Application for Licence Amendment

Licence Number	L6168/1991/11
Licence Holder	BHP Iron Ore Pty Ltd
ACN	008 700 981
App Number	APP-0034351
Premises	Yandi (Marillana Creek) Iron Ore Mine Mining Tenements M270SA, G47/12, G47/13, G47/14, G47/15, G47/16, G47/17, G47/18 and G47/19 As defined by the Premises maps attached to the Revised Licence
Date of Report	09/06/2026 (FINAL)
Decision	Revised licence granted

Figure 1: Trial Stage 2 injection and monitoring bore network

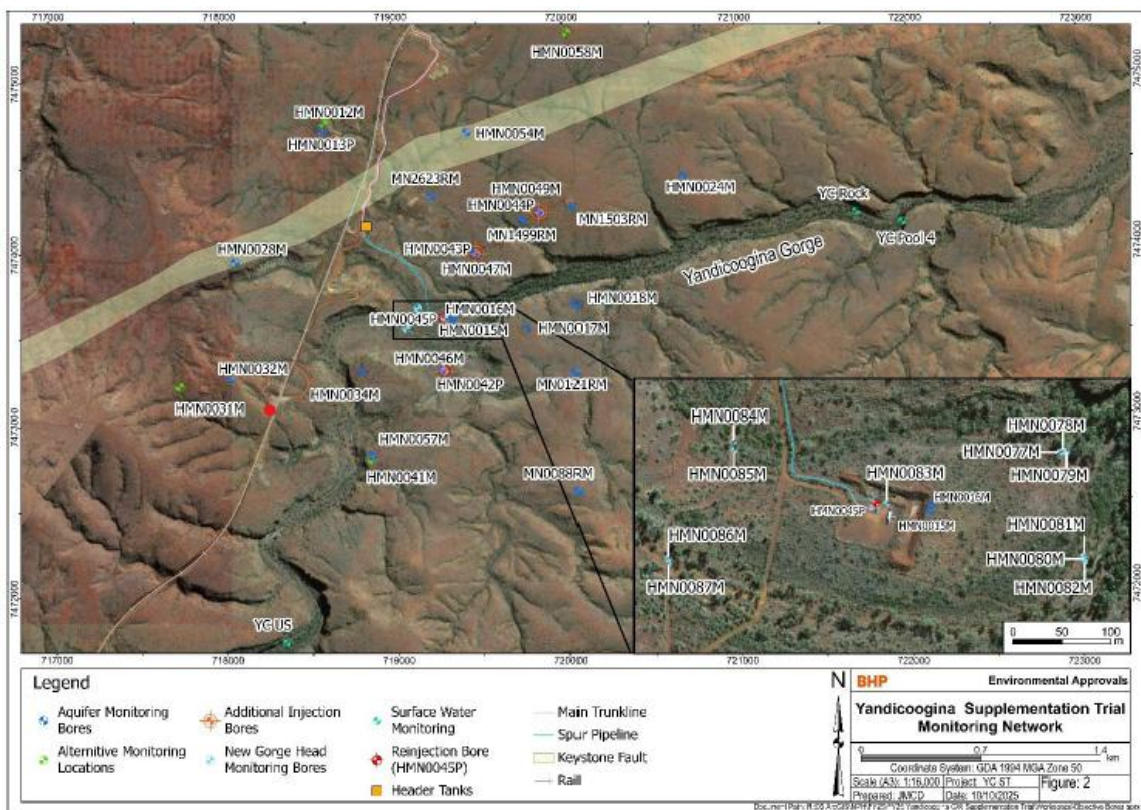
The primary injection bores for supplementation are located near the Gorge (HMN0042 – 45P), with the remaining bores planned to be used for periodic pump testing to improve the hydrogeological conceptualisation. Figure 1 depicts the bore network for Stage 2. The actual injection rate will be determined via monitoring and adherence to thresholds and triggers to achieve the objectives of the trial. The conveyance infrastructure has a maximum capacity of 2.7 ML/day.

Sample type	Sample point	Parameter	Frequency	Trigger level
Injection Location	Minimum of 6 monitoring wells within 500 m of the injection locations (see Figure 1) Specific locations will be determined based on which injection bore is being utilised at that specific stage of the trial	Water Quality Analytical Suite (parameters listed in Table 15 of Part V Licence L6168/1991/11)	Monthly during first 3 months of a new injection bore being brought online. Quarterly thereafter	(EC) field measurement >1,569 uS/cm TDS >1,500 mg/L NO ₃ -N >2.4 mg/L PFOS >0.0091 µg/L PFOA >19 µg/L
		Water Level – Continuous via logger	Continuous (logger)	N/A <i>Note: trigger values set at Yandicoogina Gorge Bores HMN0077, 79, 80 and 82M</i>
Yandicoogina Creek Pool Monitoring Point	Ephemeral Pools (currently dry): YC Pool 1 YC Rock YC Pool 3	Surface water depth (m)	Continuous (remote telemetry)	No surface water expression during periods of no rainfall

The Department supports the implementation of the TARP and monitoring program. The spatial coverage, monitoring frequencies and use of trigger-based management actions provide an adequate framework to detect changes in groundwater and surface water quality as well as water levels in order to manage potential risks to Yandicoogina Gorge.
